Building Consistency Meeting Minutes – 5.4.16

Constructability

May 2016 Building Consistency Meeting

ASW (Continued)

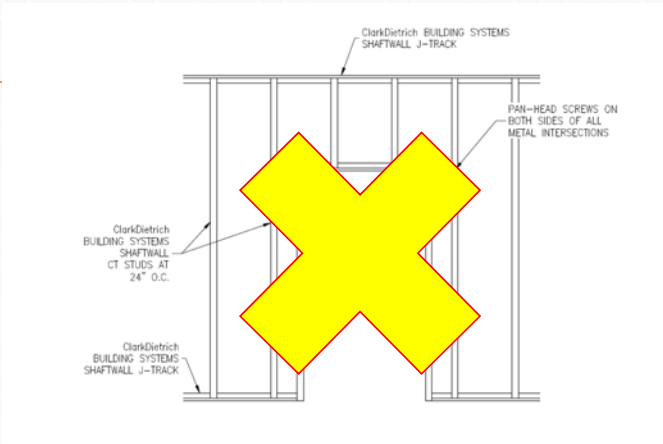
- Has never been Tested for openings!
- These walls have never been tested to NFPA 80
- ASW projects that have been approved prior must have Eng. design on the portal frame.

ASW (Continued)

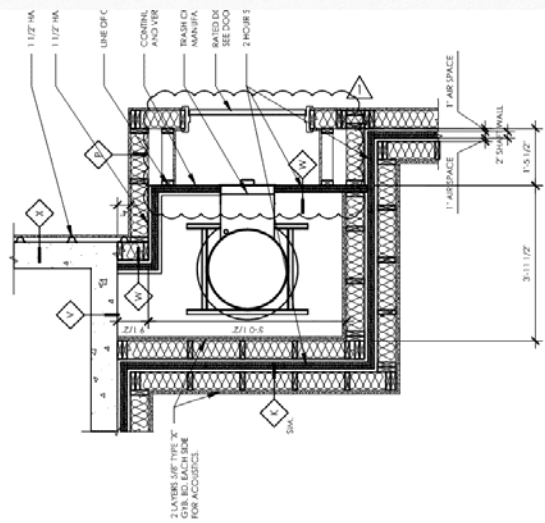
- This is why ASW doesn't work for shafts!

ASW (Continued)

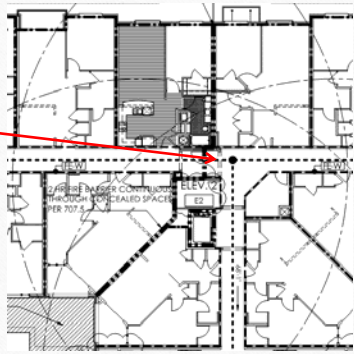
- ASW walls have been used previously as horizontal exits. These cannot be used with the door openings.

Example of Incorrect Construction

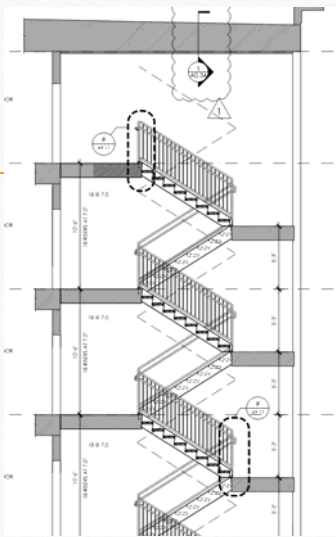
Example of Incorrect Construction

Examples of Incorrect Construction

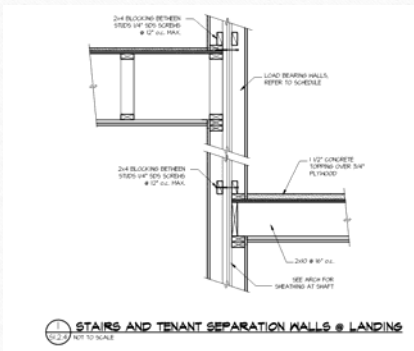
- The landing should not interrupt the wall membrane
- This is truly not constructible because of the timing of construction

Example of Incorrect Fire Barrier

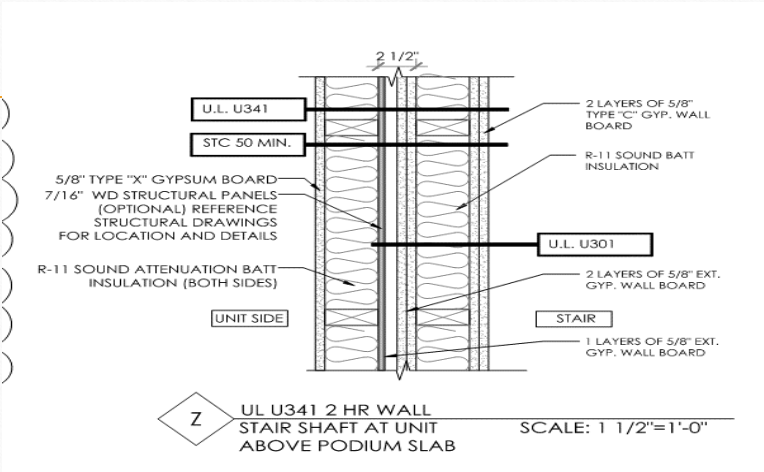
Not Constructible

Not Constructible

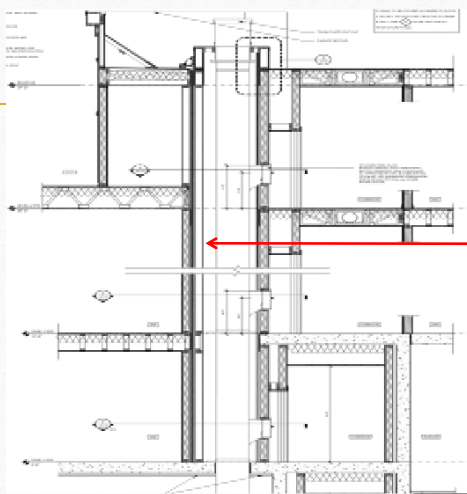
- Wood framed wall cannot be built and finished

Shaft enclosure with access

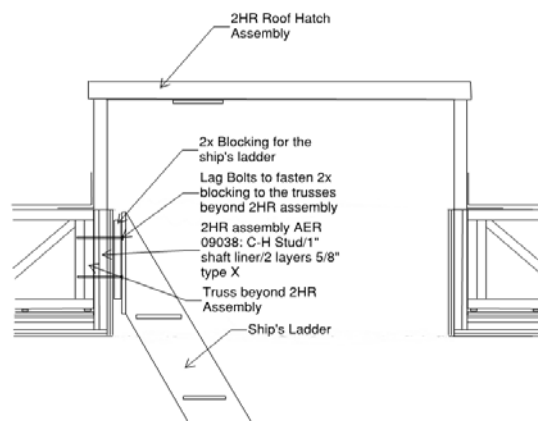
- This cannot be efficiently constructed
- What is wrong with this?
